Re: FortisBC Inc. (FortisBC) Application for a Certificate of Public Convenience and Necessity (CPCN) for the Advanced Metering Infrastructure Project – Responses to Intervener Information Request No. 3

FortisBC Inc. (FortisBC or the Company) Application for a Certificate of Public Convenience and Necessity for the Advanced Metering Infrastructure Project	Submission Date: February 22, 2012
Response to British Columbia Sustainable Energy Association Information Request (IR) No. 3	Page 1

Figure 3.1 Simplified European vs. North American Distribution Network Architectures

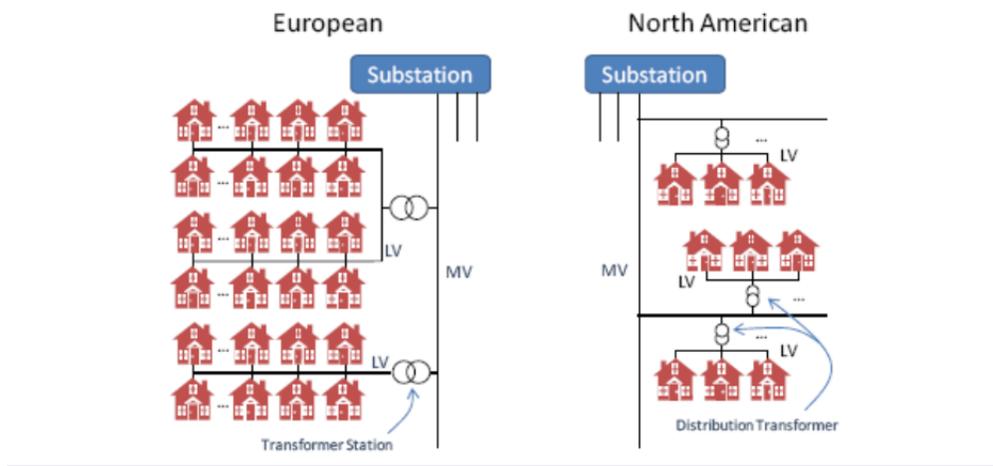
22 113.1 Please confirm that the following is text and graphic from the PikeResearch
23 report immediately preceding the text quoted in Exhibit B-23 that may clarify how
24 the different power system architecture in Europe compared to North America
25 affects the comparative costs of PLC and wireless metering systems:
